SUBJECT: Administrative Approval for Petition No. 2015-053 Lat Purser & Associates

PROPOSED DEVELOPMENT

MONTFORD DRIVE & PARK ROAD
 CHARLOTTE, NORTH CAROLINA

Petition No. 2015-053
 For Administrative
 Amendment

01 SITE PLAN

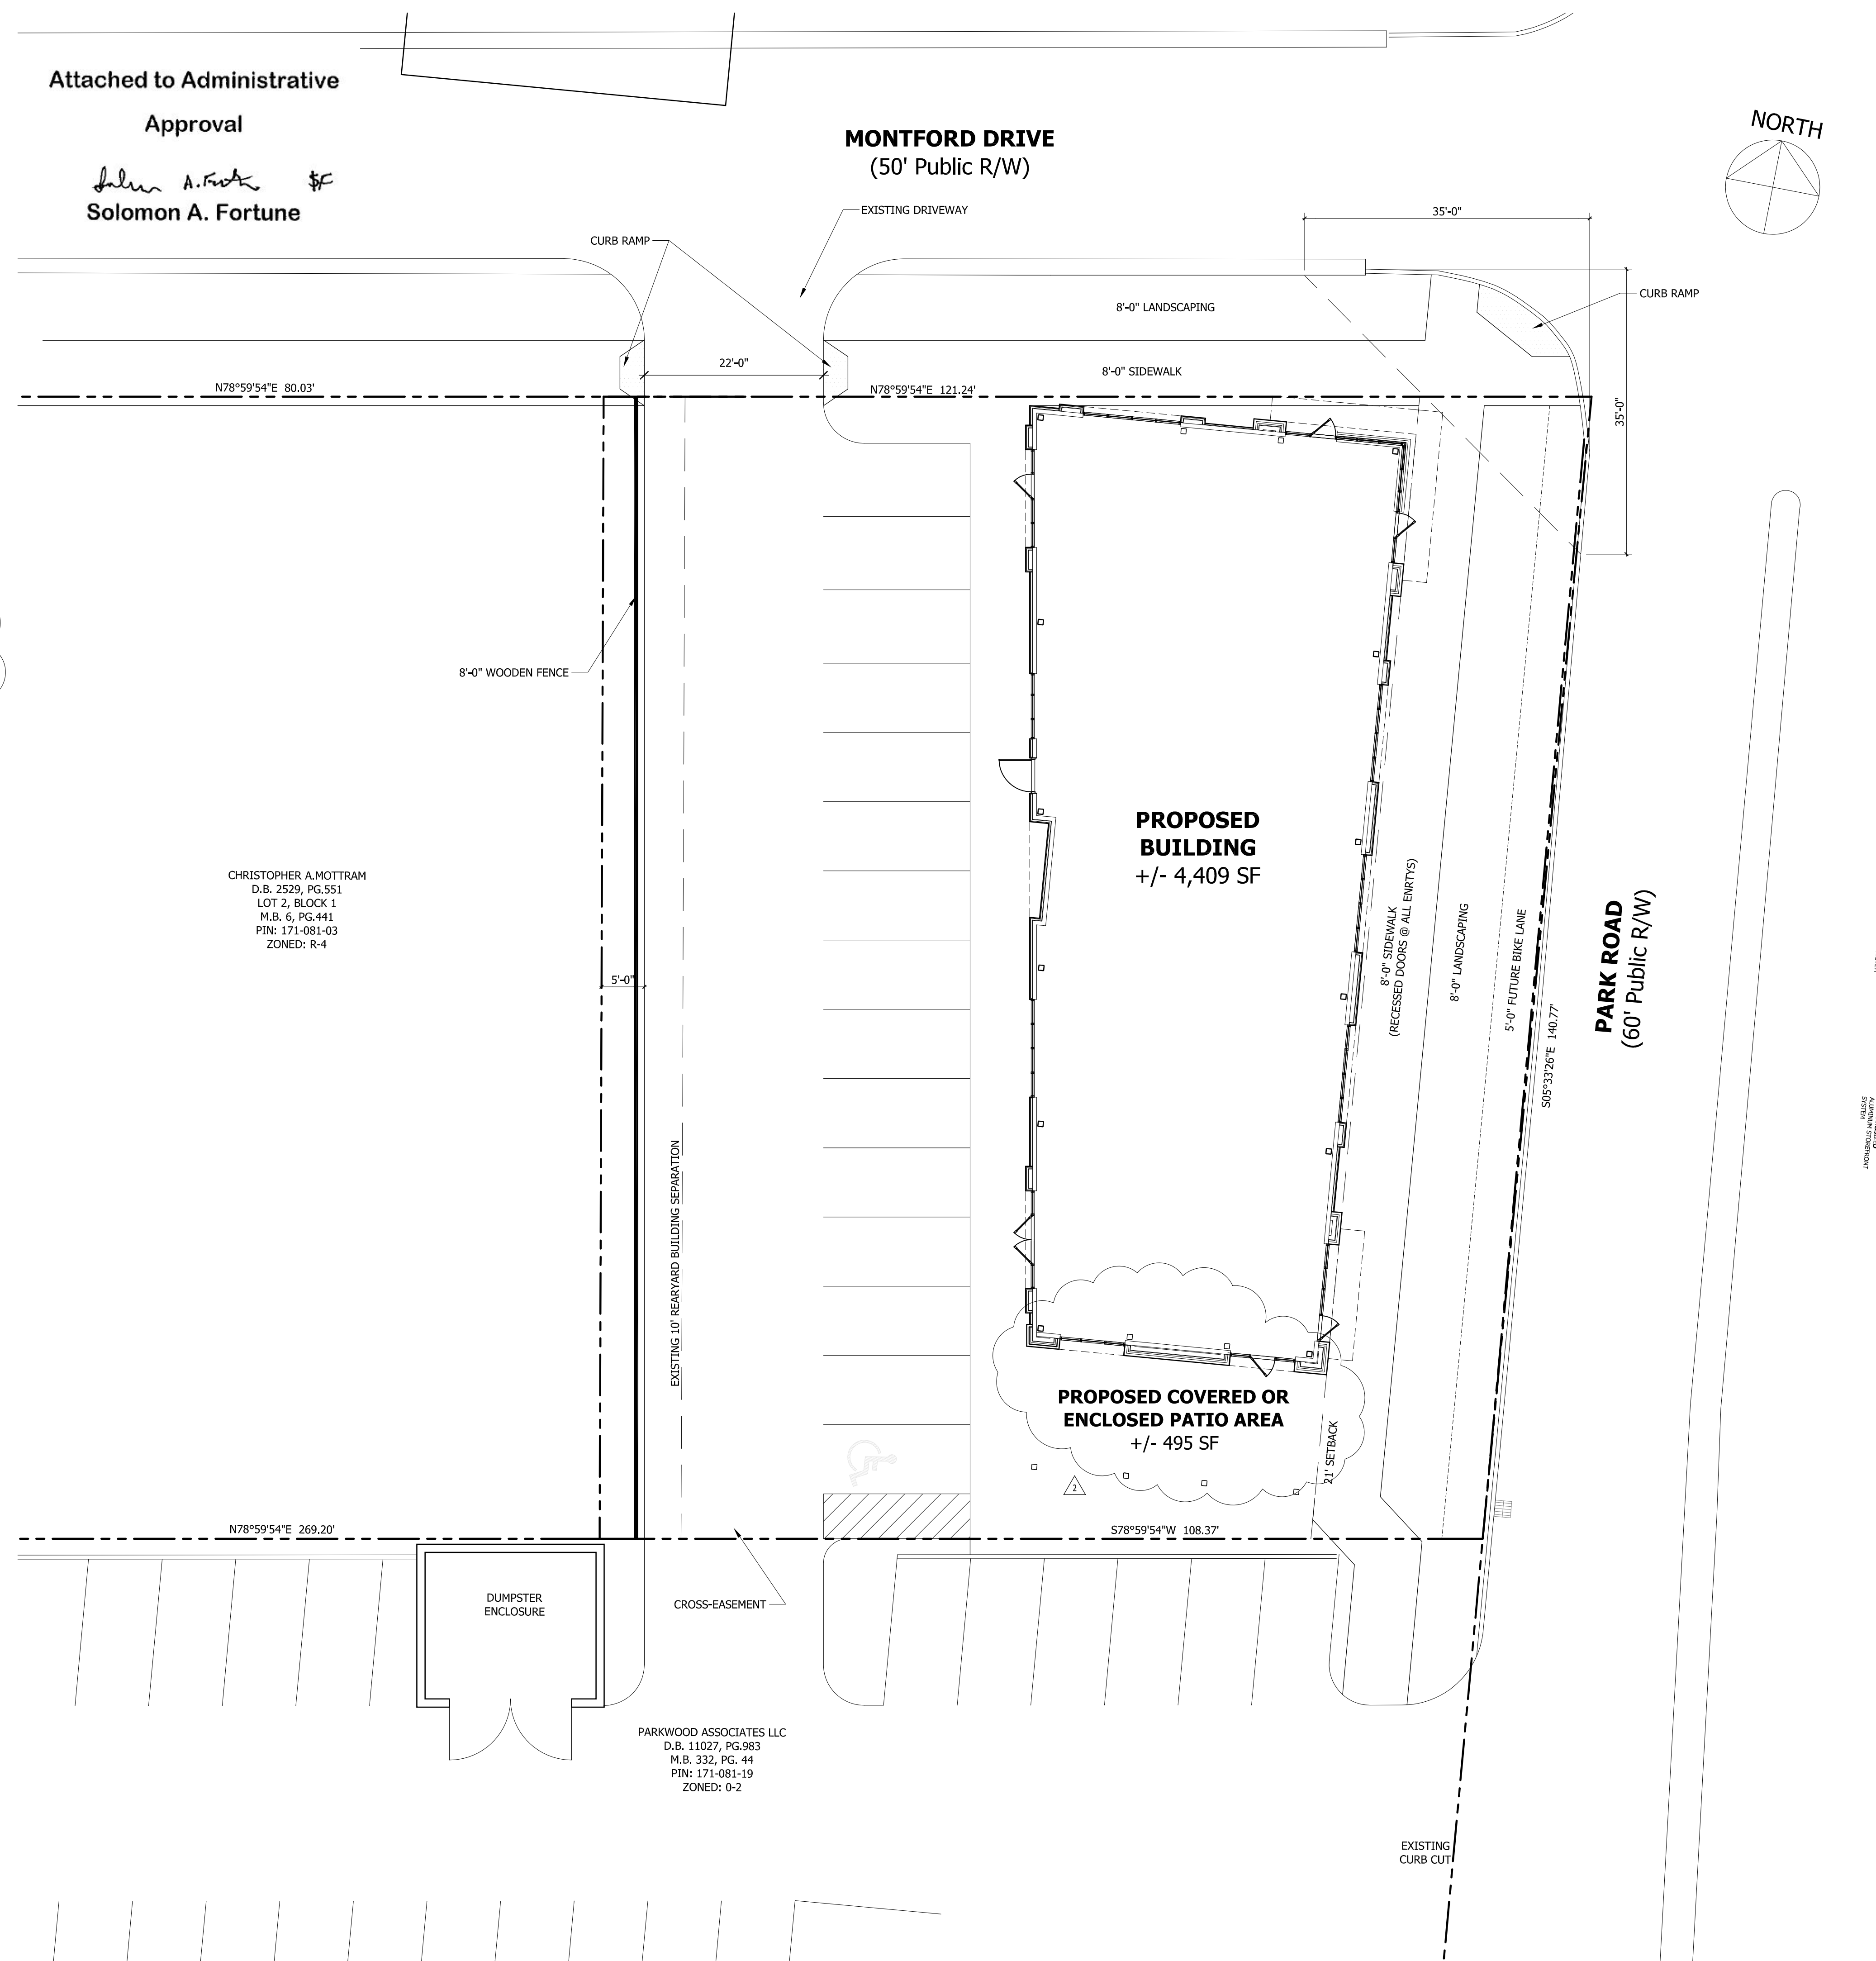
- 470 square footage addition per section 6.207 for outdoor dining area and principal building.
- Possible enclosed outdoor dining area.
- Building Elevations
